SERVICE BULLETIN SB-44

DATE: 01 August 2001

SUBJECT: Hydraulic Pump Lines and Fittings

ROTORCRAFT AFFECTED: **Part A:** R44 Helicopters S/N 0002 thru 1102 with hydraulically-boosted main rotor flight controls.
Part B: R44 Helicopters S/N 0611, 0653, 0655, 0661, and 0663 thru 0693 except 0666 and 0679.

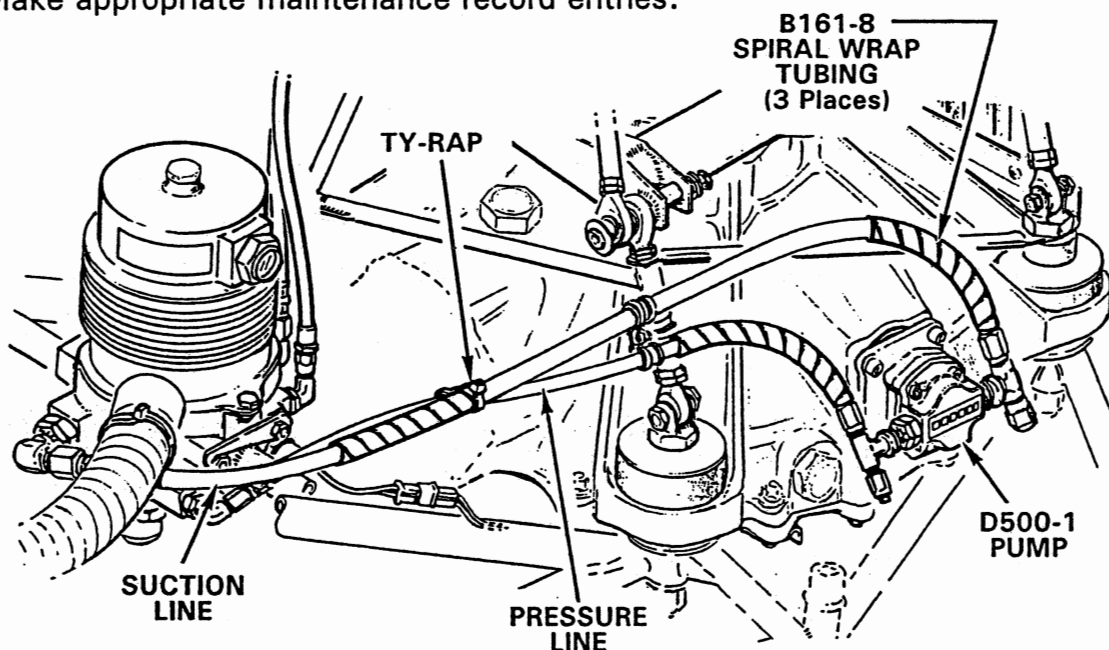
1. Verify 0.25 inch minimum clearance between auxiliary fuel tank and both hydraulic pump lines.
2. If clearance is less than 0.25 inch, inspect fuel tank for chafing. If tank has not been chafed, reposition lines and fittings as required to obtain 0.25 inch clearance. Torque line and fitting nuts per R44 MM Section 1.330 and torque stripe. If torquing suction line B-nuts, use 200 inch-pounds to avoid stripping fittings.

3. If fuel tank has been chafed, remove tank per R44 MM section 12.140 and measure depth of damage. Contact RHC Technical Support for repair instructions.
4. Install 6-inch sections of B161-8 spiral wrap tubing on hydraulic lines as shown below. (Spiral wrap tubing is enclosed. Additional tubing may be ordered from RHC Customer Service.)
5. Make appropriate maintenance record entries.
